MIDLAND UNITS 1 & 2
JOB NO. 7220

REVIEW OF U.S. TESTING
FIELD AND LABORATORY CONSTRUCTION
TEST DATA ON SOILS USED AS FILL

BECHTEL ASSOCIATES PROFESSIONAL CORPORATION
July 1979

FIGURE 1

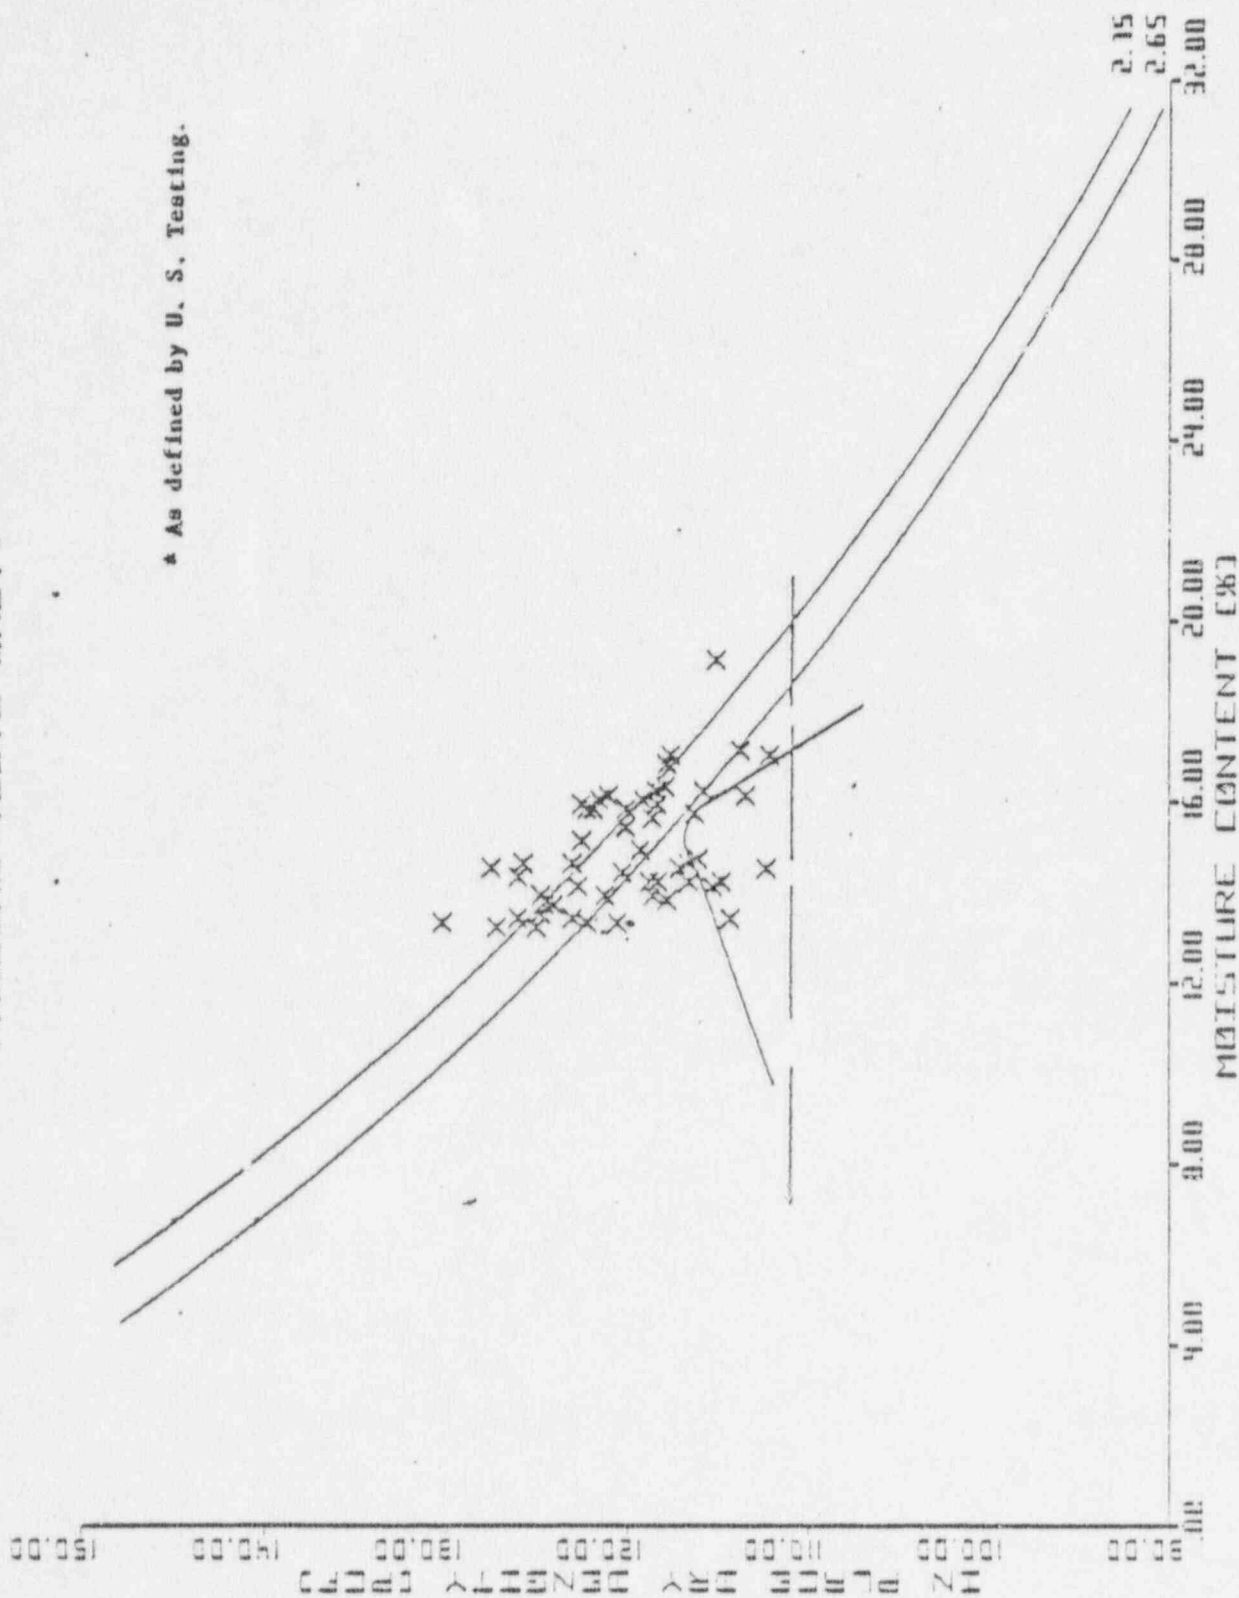
The fact that a large number of test results plot above the zero air voids curve tends to make all test results questionable.

Also, referring to Figure 1 it would appear that soil density varied widely. Specifications called for compactive effort results as defined by ASTM D 1557 which is 56,255 ft-lb/ft³ energy. This was modified to a laboratory test compactive effort of about 20,000 ft-lb/ft³ energy, often referred to as Beachel Modified Proctor (BMP). Laboratory compaction test curves should be related to the same effort as that called for in the field for use in comparing with field density tests to determine percent compaction. According to plots of field data shown on Figure 1, density varied from about 108 lb/ft³ to about 130 lb/ft³. It is doubtful that the soil classification or other properties would be similar for such a wide variation in density. It is noted that 100 percent of modified Proctor (ASTM D 1557) which is difficult to obtain, is rated at 56,255 ft-lb/ft³ energy. The curve plotted on Figure 1 is at about 20,000 ft-lb/ft³ energy. For comparative purposes it was determined by U. S. Testing in 1974 that 100 percent of specified effort (20,000 ft-lb/ft³) is approximately equal to 95 percent of the maximum density as determined by ASTM D 1557 (56,255 ft-lb/ft³) Reference Figure 8.

FIGURE 7: WINDOWS OF ACCEPTABILITY (A) BASED ON BMP SPECIFICATION (B) REGARDLESS OF EXACT WORDING OF SPECIFICATION

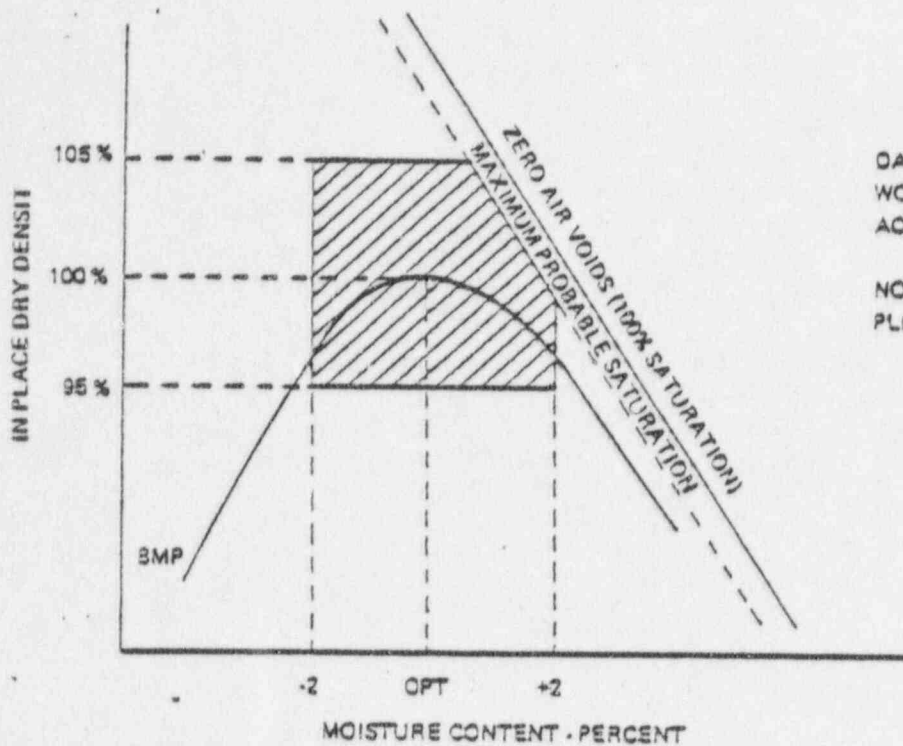
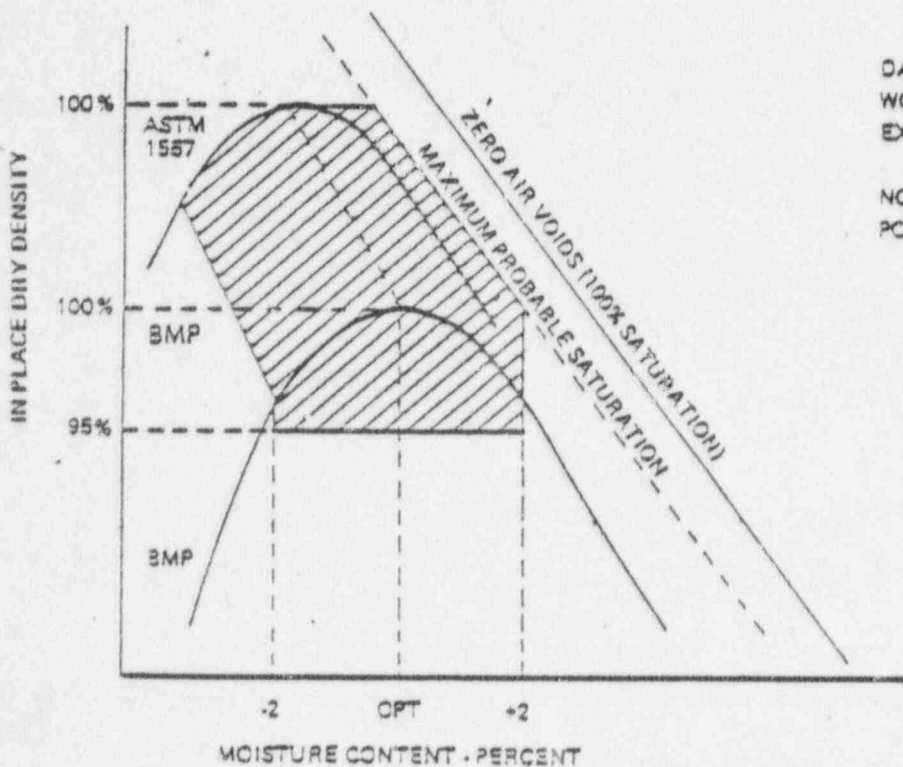
For a field test result to be valid as well as "Passing" it must fall within a well defined area on the plot containing the laboratory compaction curve. This area or window of acceptability is shown for a hypothetical compaction curve on Figure 7a that would meet requirements of Specification 7220-C-210. It is defined by horizontal lines at 95 percent and 105 percent of specified density, vertical lines through ± 2 percent of optimum moisture content, and a line parallel to the zero voids line indicating saturation about half way between the compaction curve and 100 percent saturation (zero air voids curve). The practical upper limit of 105 percent of specified density is not defined in the specifications. It was arbitrarily chosen as numbers greater than this give increasingly invalid comparisons between field test results and the specified laboratory compaction test curve. Therefore, if all data points fall within the defined window there would be no reason to assume that they are wrong. However, when many data points fall outside the designated area there is something wrong with the information and then all data points become suspect. A review of all data indicates that about 25 percent of the cohesive soil test results fall within this area.

Figure 7B shows an area where field test results would be acceptable, in theory even though not in strict accordance with the specifications. Figure 7B was arrived at by expanding Figure 7a to include test results up to a compactive effort related to ASTM D 1557 (56,255 ft-lb/ft³) which is considered to be a practical upper limit. About 40 percent of all cohesive soil test results would plot in this area.

DATA POINTS THAT PLOT IN SHADED AREA WOULD BE GENERALLY ACCEPTABLE ACCORDING TO SPECIFICATIONS

NOTE: ABOUT 25% OF ALL FIELD DATA PLOTS IN THE SHADED AREA

FIGURE 9

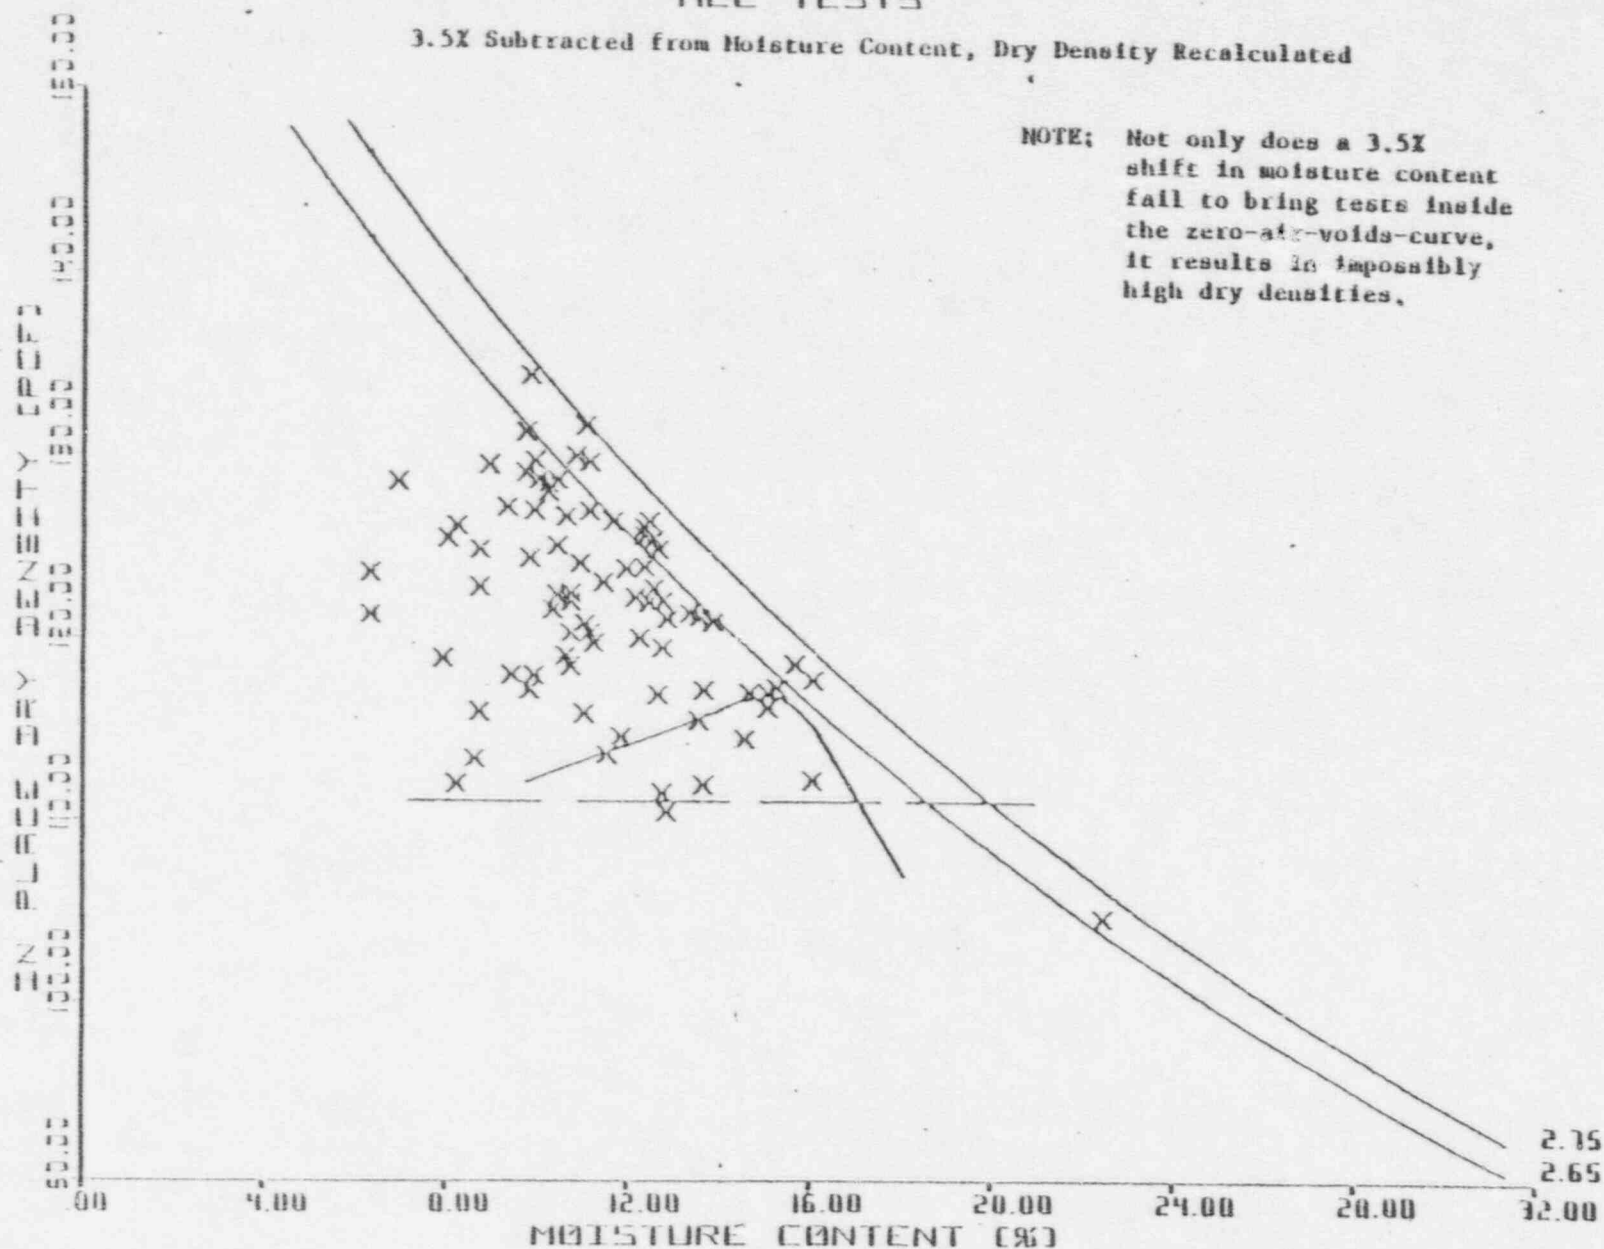
In a letter from U. S. Testing to Bechtel (dated May 30, 1974), the average deviation of the nuclear device from oven-dry moistures was $\pm 1.12\%$ for a set of 30 tests. However, the standard error of estimate is 1.6% for the data with the range of differences being from -3.2% to $+3.9\%$. Thus, accuracy of the nuclear device is questionable, and could translate into errors of about ± 4 pcf in the dry density calculation. (It should be noted that errors in the moisture content tend to shift the position of test results on a moisture density plot approximately parallel to the zero air voids curve, assuming the in-place wet density is correct, and thus do not explain the large number of points which plot outside the zero air voids. Compare Figures 1 and 9).

3.5% Subtracted from Moisture Content, Dry Density Recalculated

NOTE: Not only does a 3.5% shift in moisture content fail to bring tests inside the zero-air-voids-curve, it results in impossibly high dry densities.

FIGURE 10
CHANGE IN RELATIVE DENSITY SCALE FROM DRY TO WET METHODS
OF OBTAINING MAXIMUM DENSITY, BASED ON RECENT LAB RESULTS

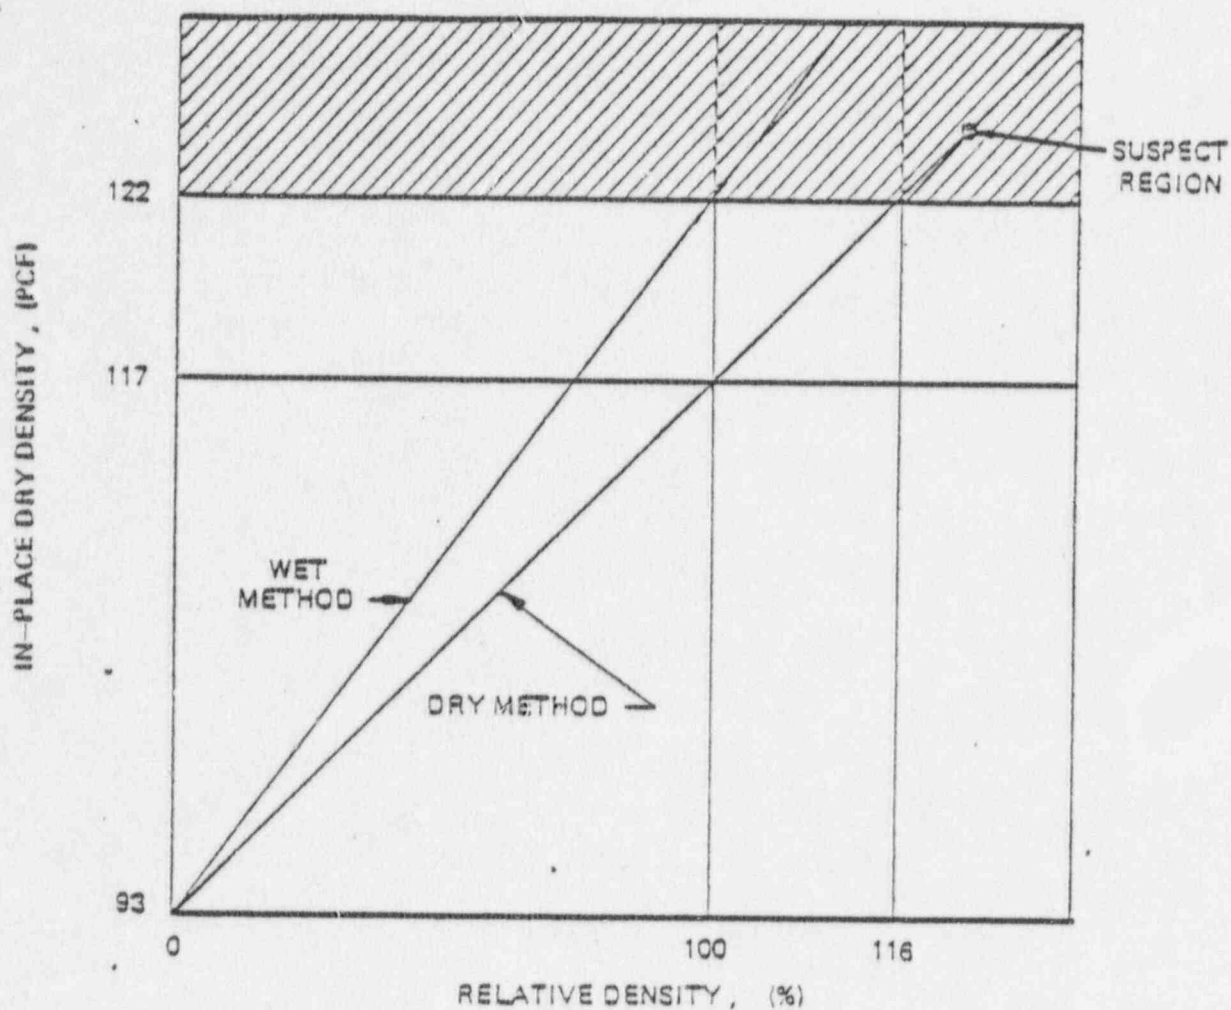
ASTM D 2049 section 7.1.2 Wet Method states: "Note 2 - While the dry method is preferred from the standpoint of securing results in a shorter period of time, the highest maximum density is obtained for some soils in a saturated state. At the beginning of a laboratory test program, or when a radical change of materials occurs, the maximum density test should be performed on both wet and dry soil to determine which method results in the higher maximum density. If the wet method produces higher maximum densities (in excess of one percent) it shall be followed in succeeding tests." An example of wet and dry relative density is shown on Figure 10. U. S. Testing Company apparently did not do this frequently enough, or on a broad enough range of non-cohesive soil types. As a consequence many field density test results exceed 100 percent of maximum dry laboratory relative density. As an example, for laboratory test RD55 a total of 366 field tests were made. Of this total, 364 tests were greater than 100 percent compaction. The highest relative density found was 142.2 percent with the majority of tests over 100 percent falling in the range of 100 percent to about 130 percent. Since the difference in maximum density between wet and dry methods is about 4 to 5 lbs/c. ft. (based on recent data) any test result greater than about 115 percent (based on the dry method) is suspect.

NOTE: VALUES FOR DRY DENSITY ARE TYPICAL OF A RANDOM FILL SAND. ANY TESTS SHOWING MORE THAN 117% RELATIVE DENSITY WOULD BE SUSPECT IN THIS EXAMPLE. STRUCTURAL SANDS TEND TO SHOW ONLY 2 OR 3 PCF INCREASE IN MAXIMUM DENSITY AND THUS RESULTS AT MUCH LOWER RELATIVE DENSITY WOULD BE SUSPECT, SAY 105 - 110 PERCENT
